# Sample FRP beam and clips for Drift cage

FRP I beam used for Drift Cage. Manufacturer Rochling different from SP, never tried in LAr.

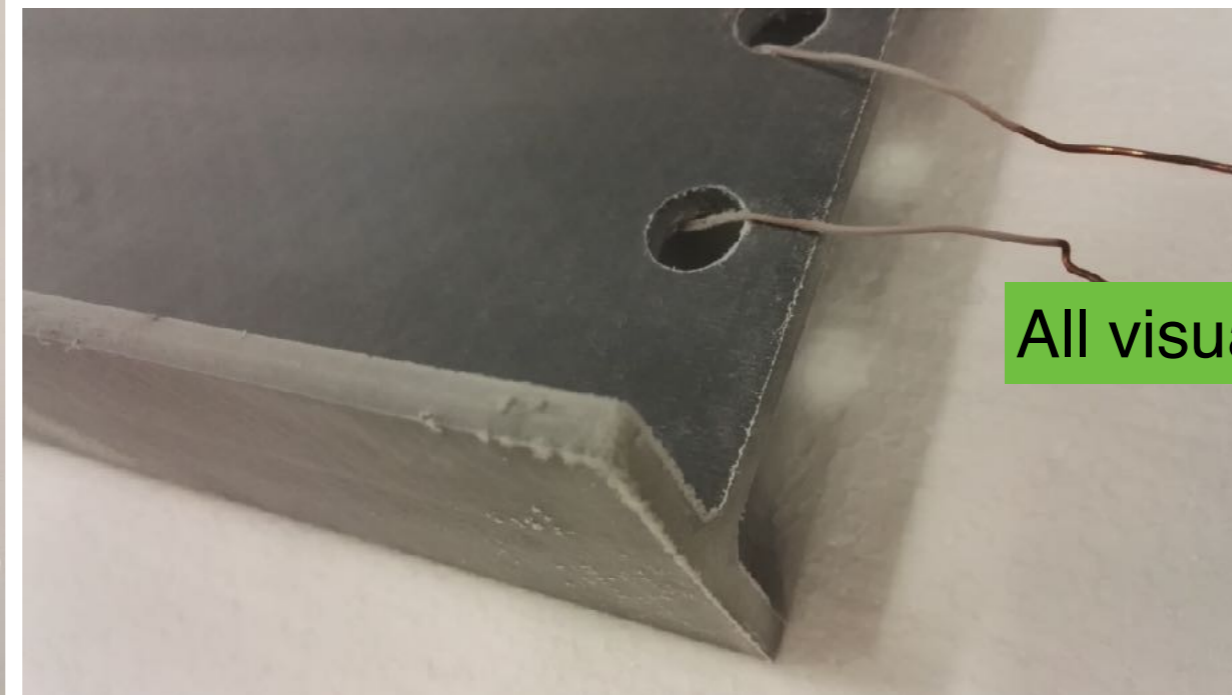
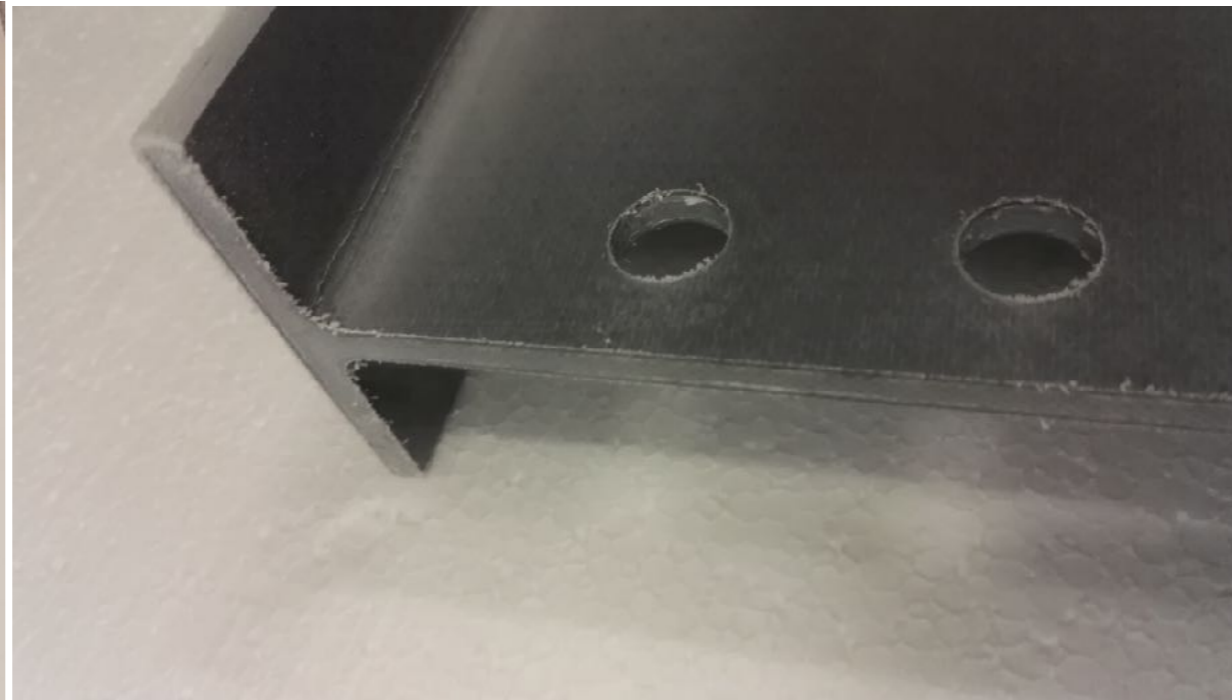
presence of residual glass fibres around hole due to drilling. Can the company take care of cleaning them?

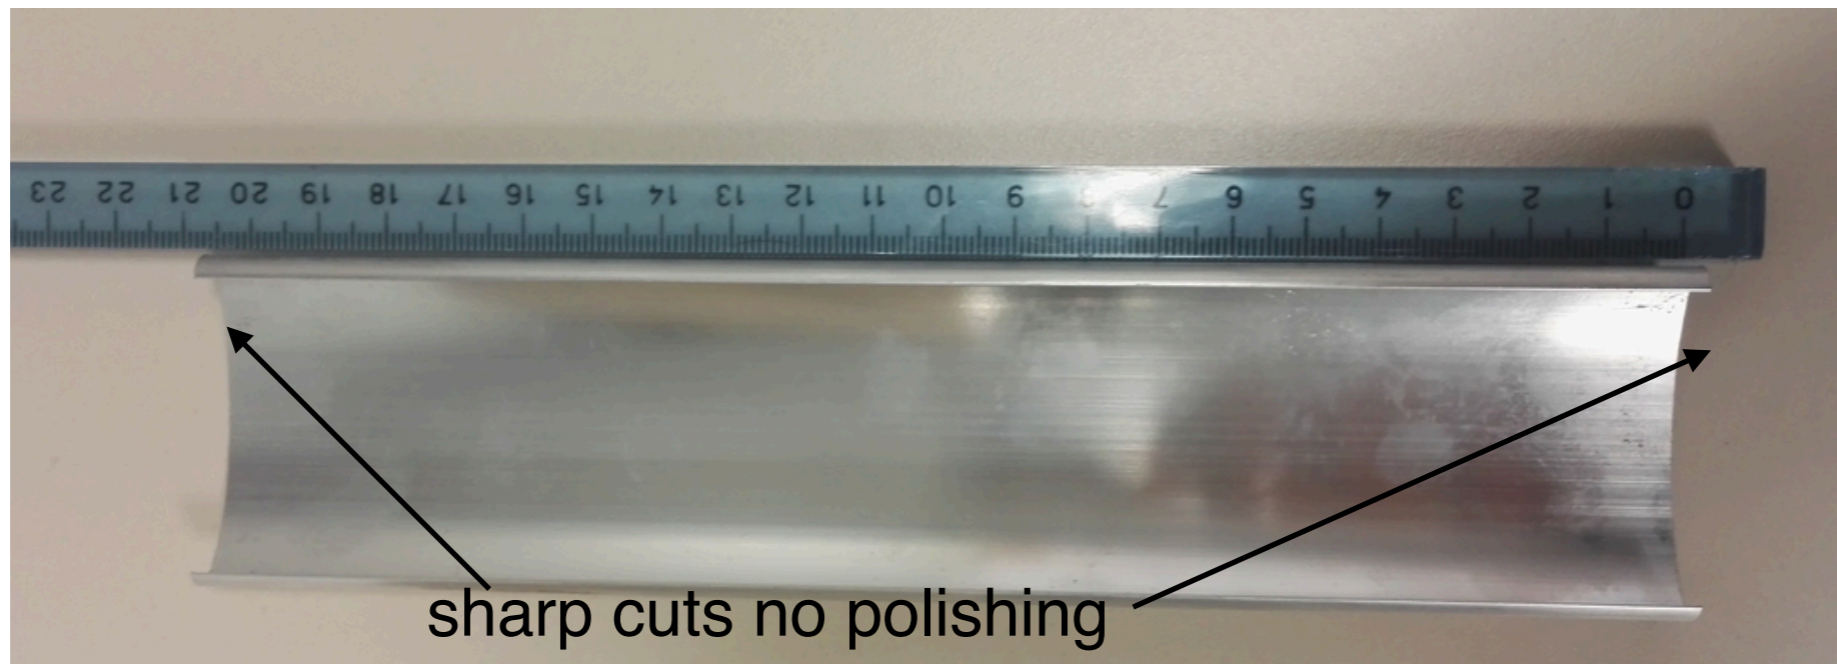
-Thickness 0.7 mm within tolerance.

-The edges were not rounded/polished->crucial for HV that they are. Already informed MIFA.

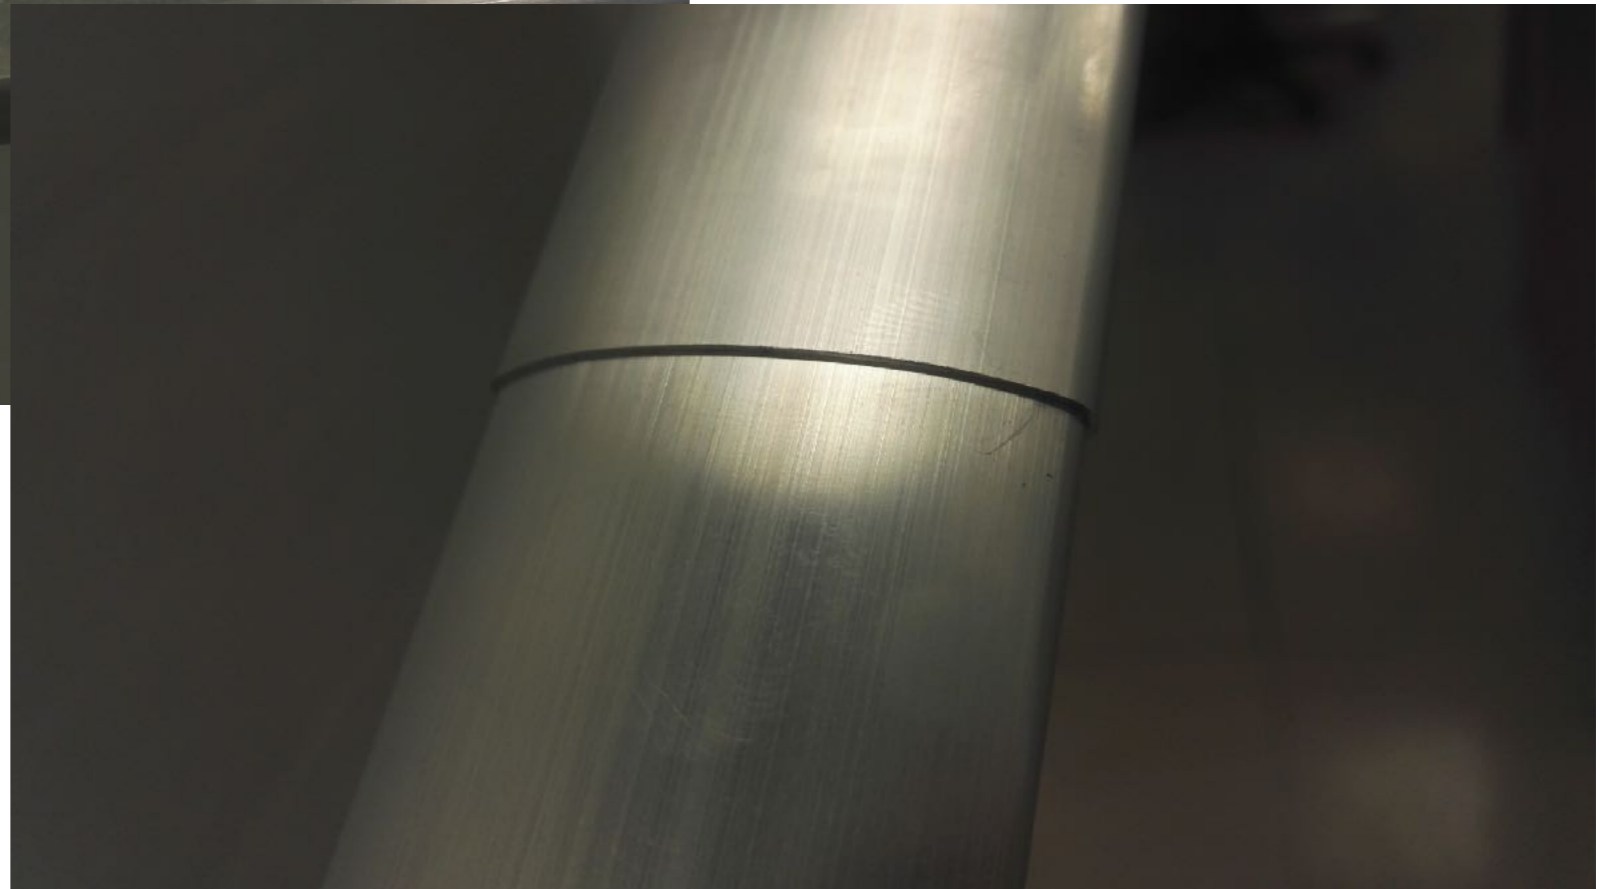
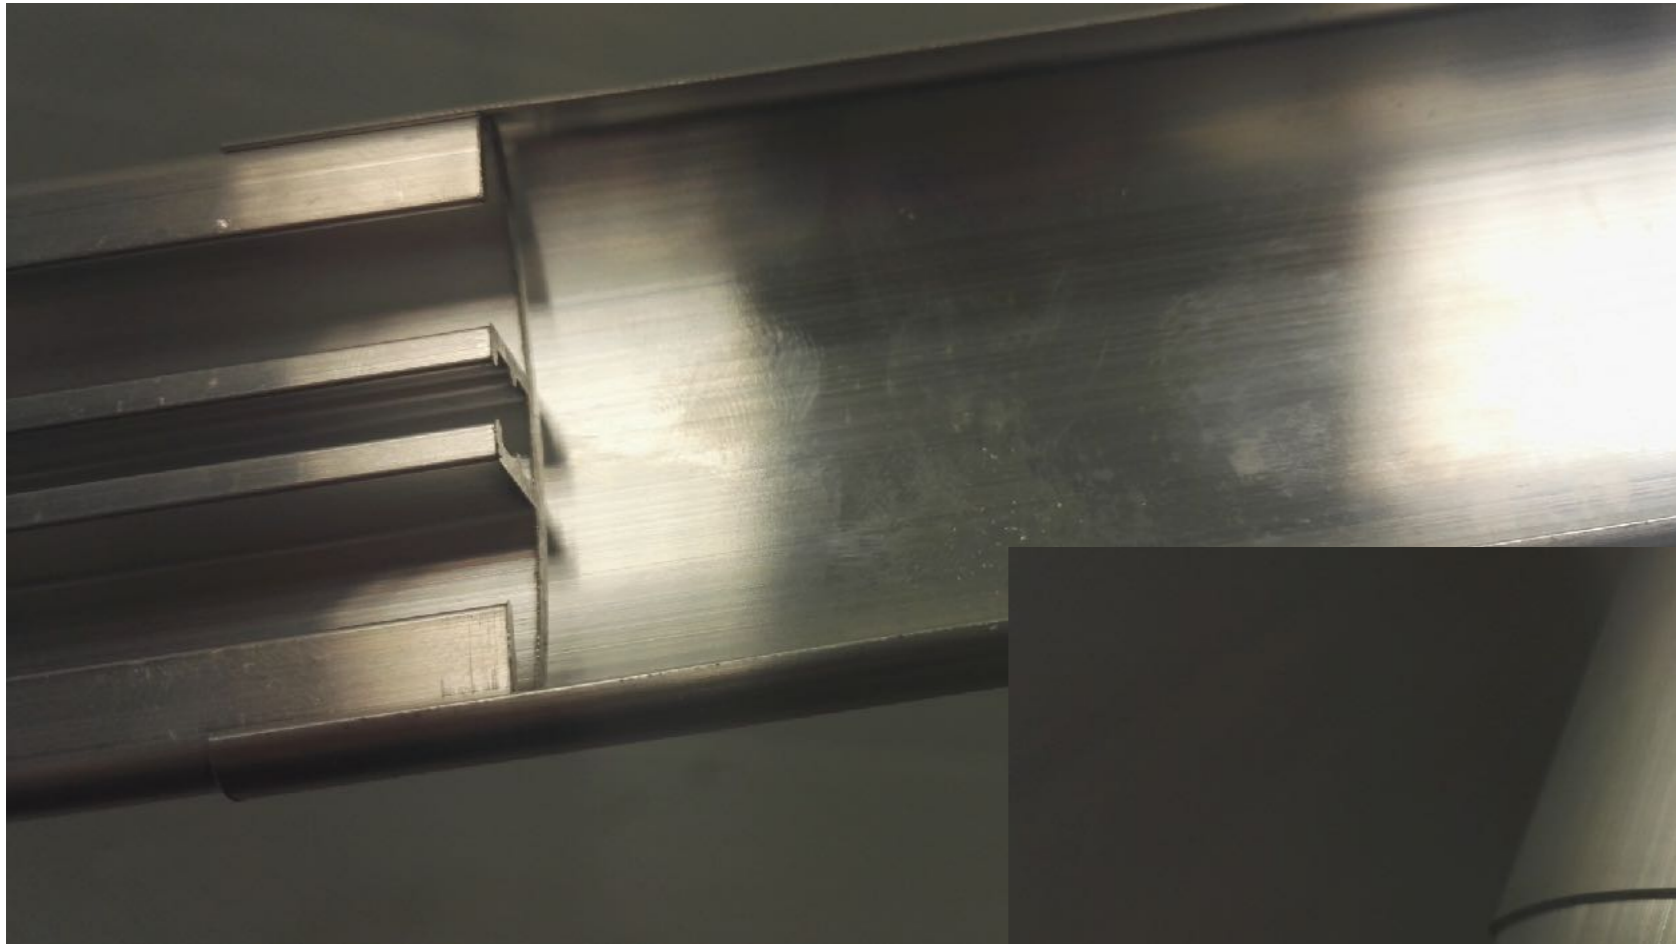
It works rather smoothly, easy to clip. Unclipping is possible but requires a bit more force. However we do not see a scenario where we would need to unclip during installation.
